A G Wright & Son Farms Ltd

Sunnica – EN1010106

Deadline 8

The Baseline report ref APP-115 dated 18th November 2021 was prepared by Daniel Baird Soil Consultants Ltd (DBSC):

Sunnica Energy Farm Proposed Layout - (Predictive BMV Land Assessment)

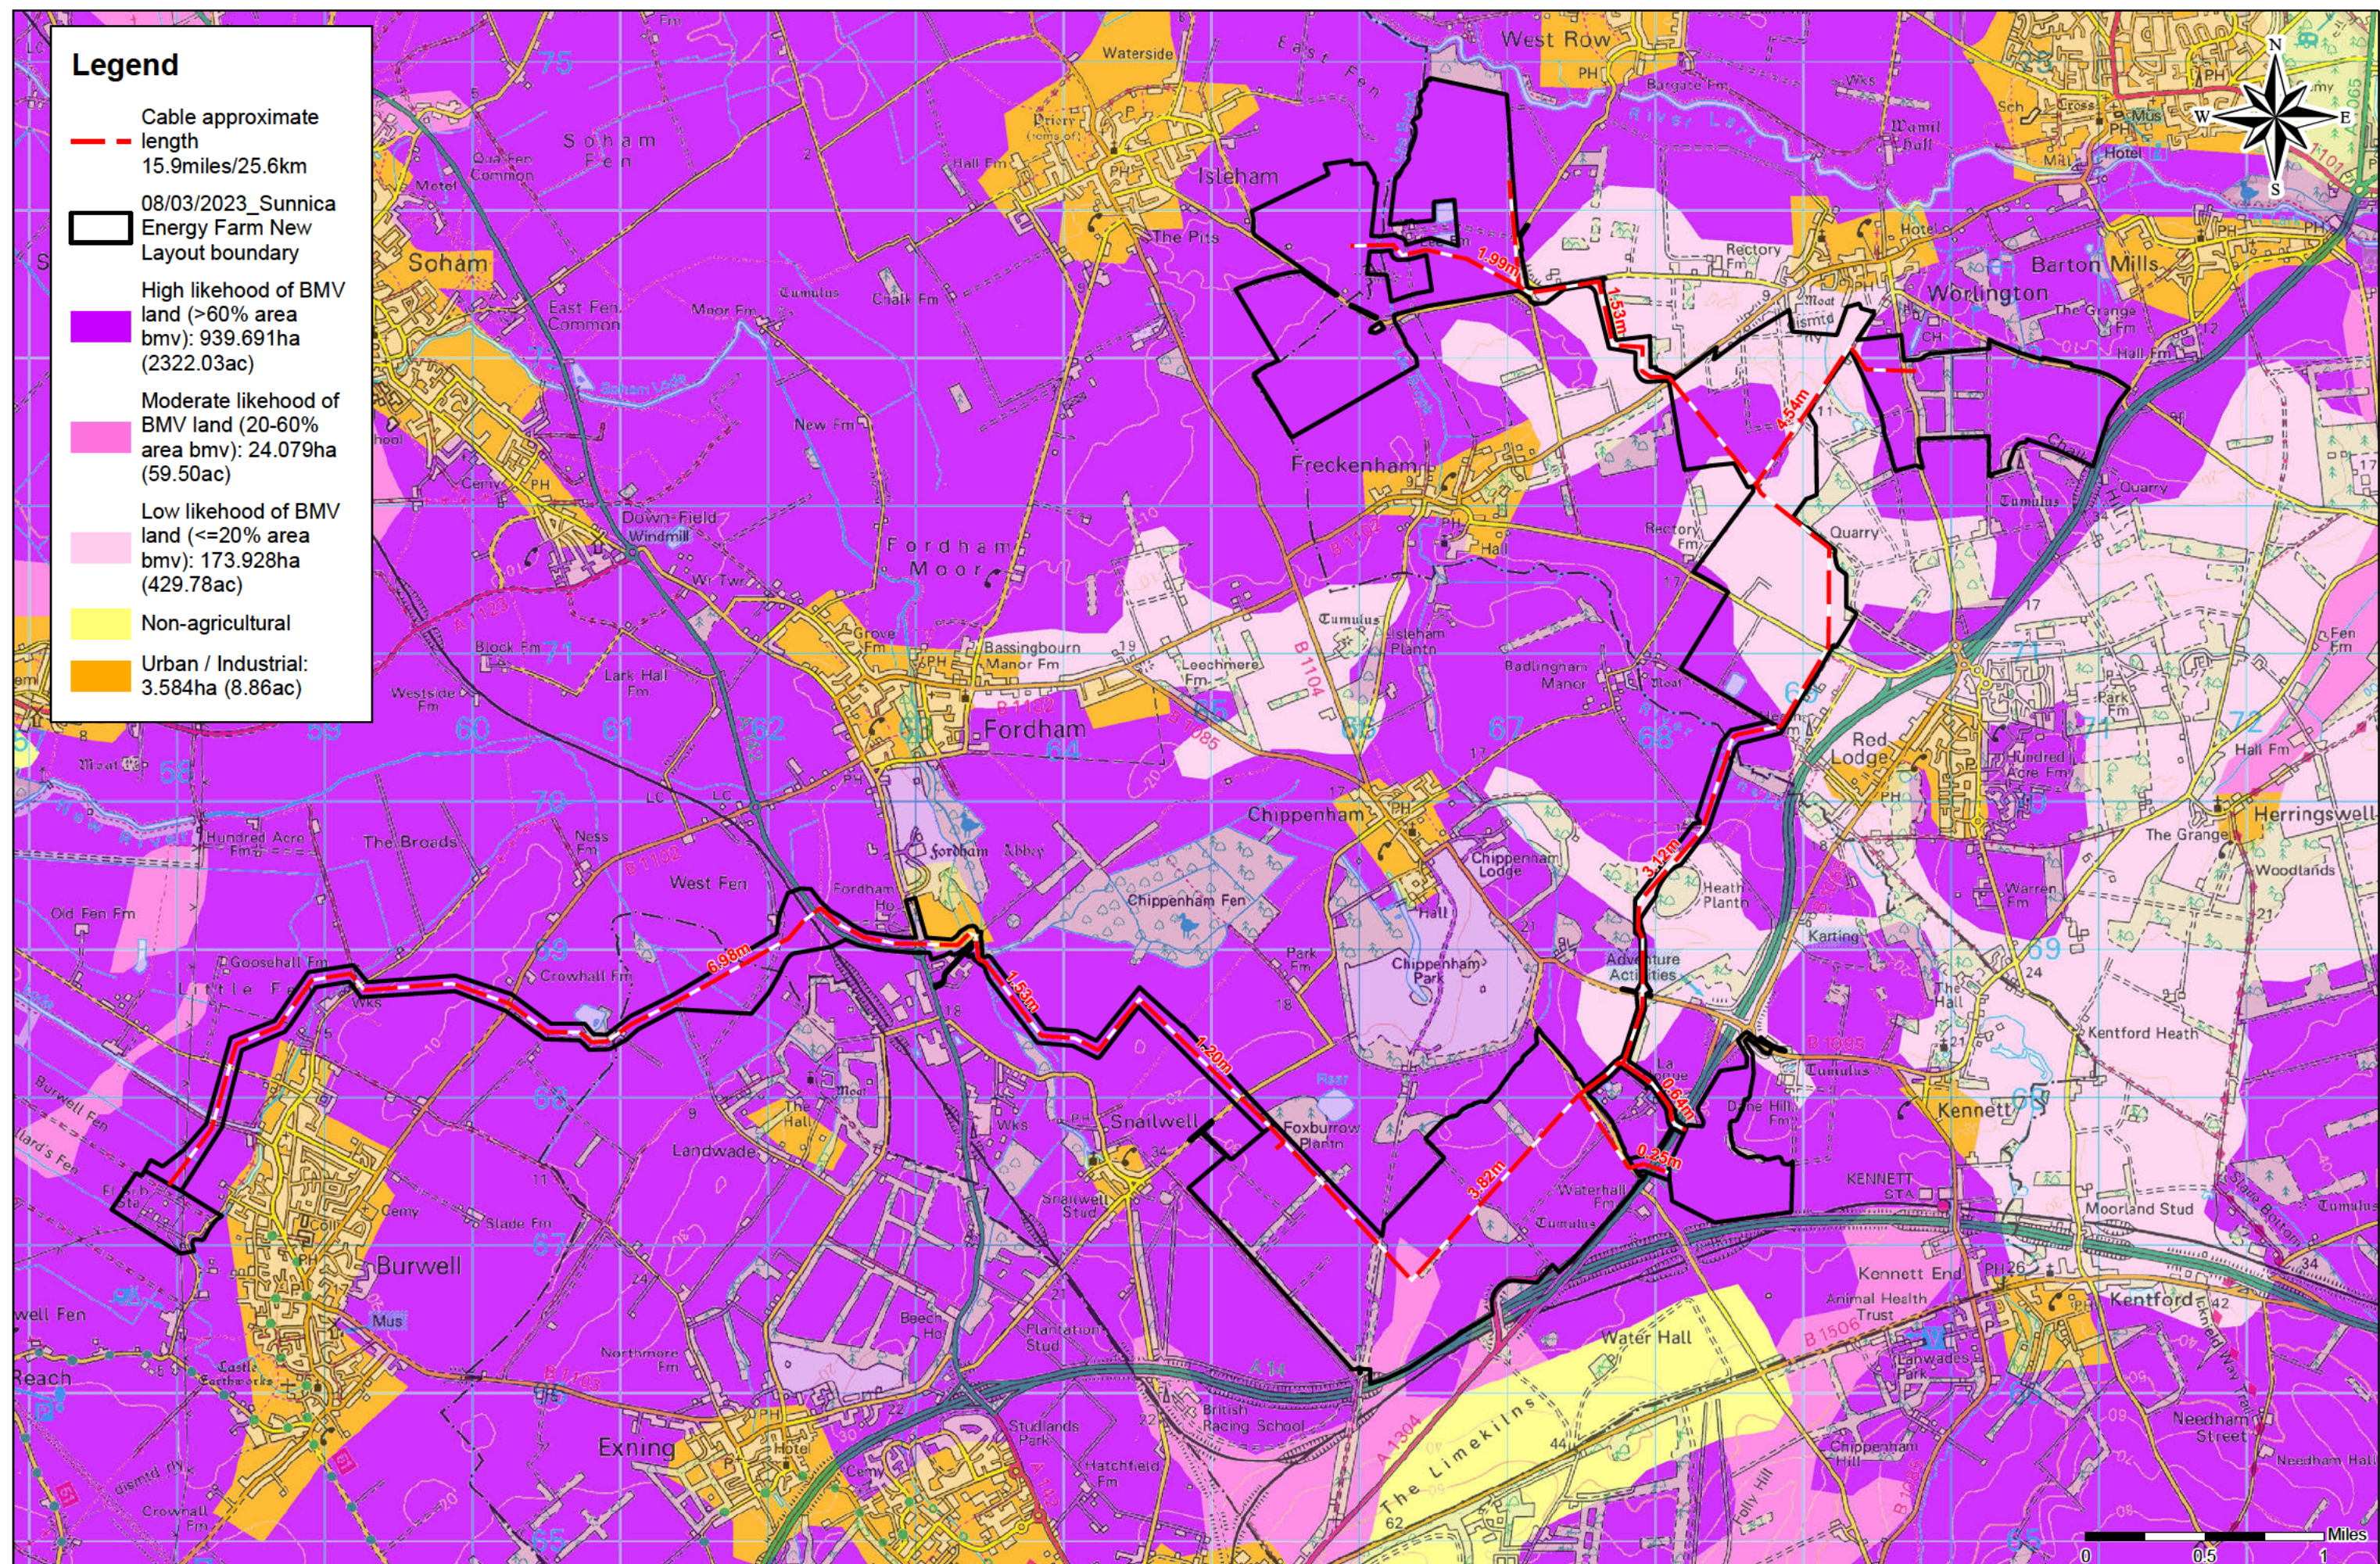
2/ The 2017 Natural England predictive BMV land assessment plan (appendix 4) shows 82% of the site as 60% or more likely to be BMV

We therefore must take the 2017 Natural England Predictive BMV land assessment plan as the document to establish the reasonable worst case for the likelihood of BMV on the site. The plan

identifies 82% of the site as potentially BMV. The Scheme should therefore be assessed on the basis that 82% of the site is BMV

APP-115 Page 82-Archeological trench picture supplied by DBS

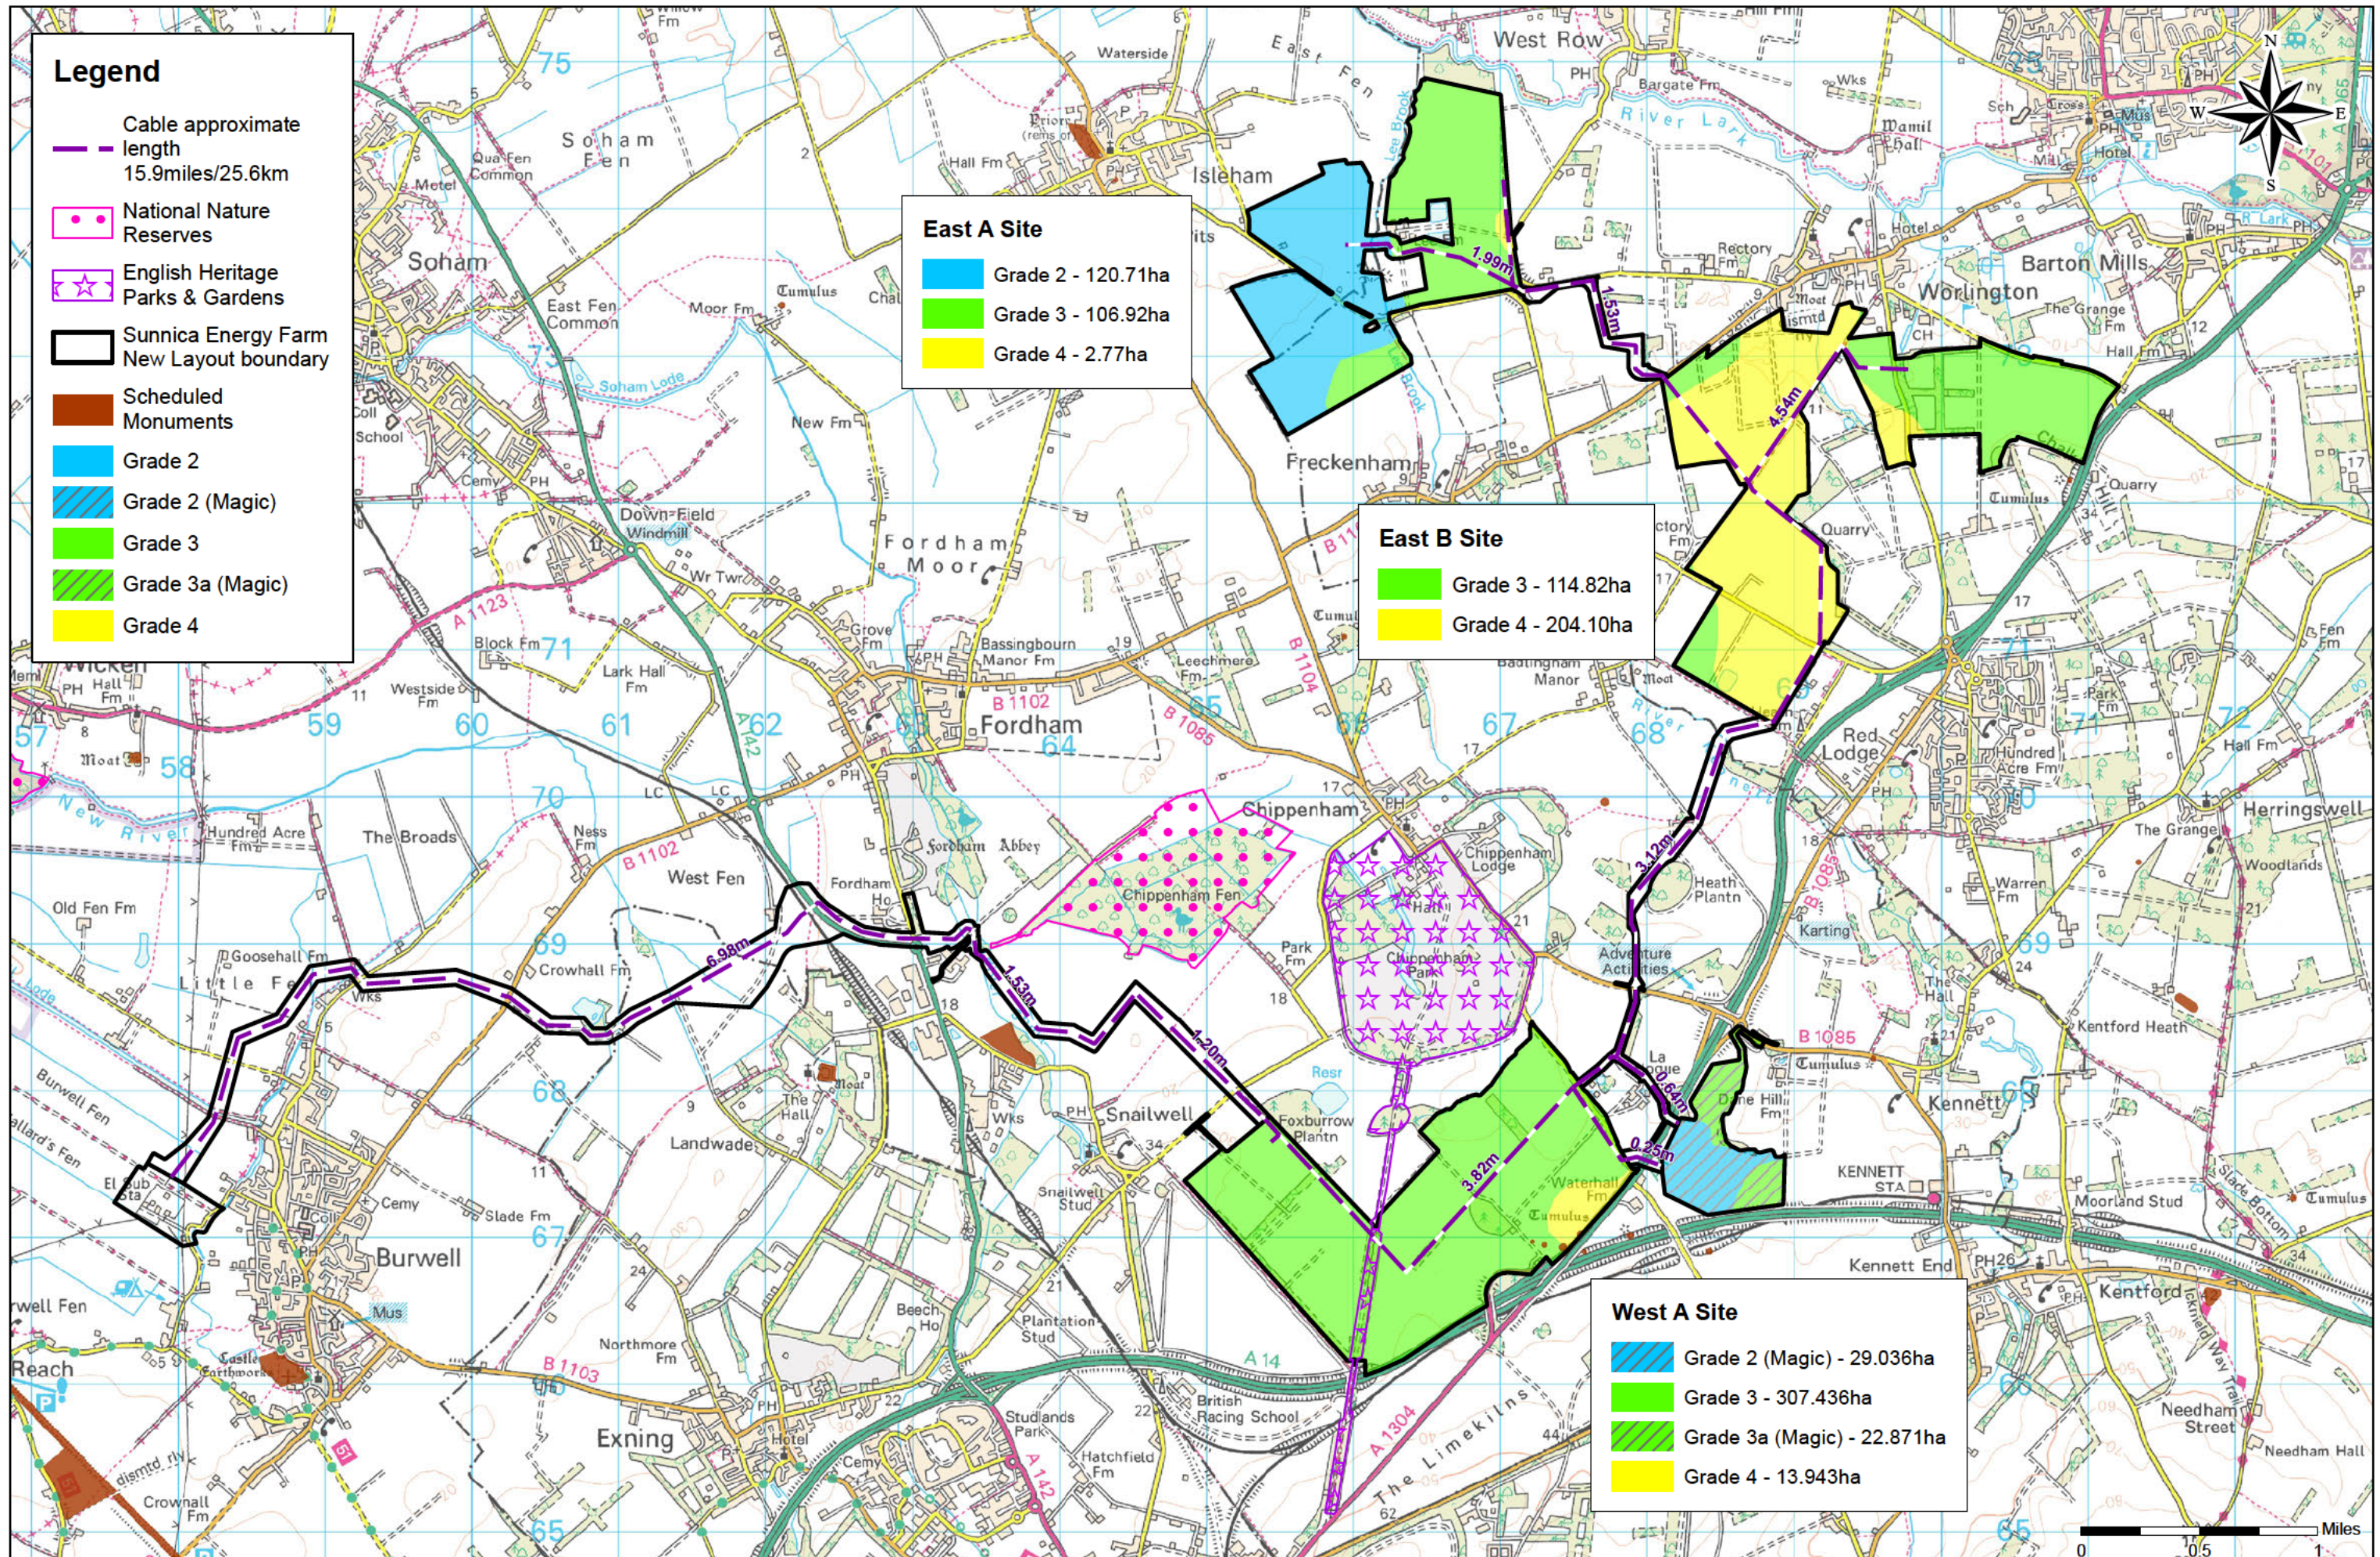
9/ No supporting photographs of any of the pits were provided, instead the applicant chose to include photographs of two archaeological pits. Please see attached at appendix 2 pictures of two archaeological pits. One provided by DBSC and one by Oxford Archaeology (OA) who carried out the Archaeological survey for the applicant. The OA trench strongly indicates BMV.
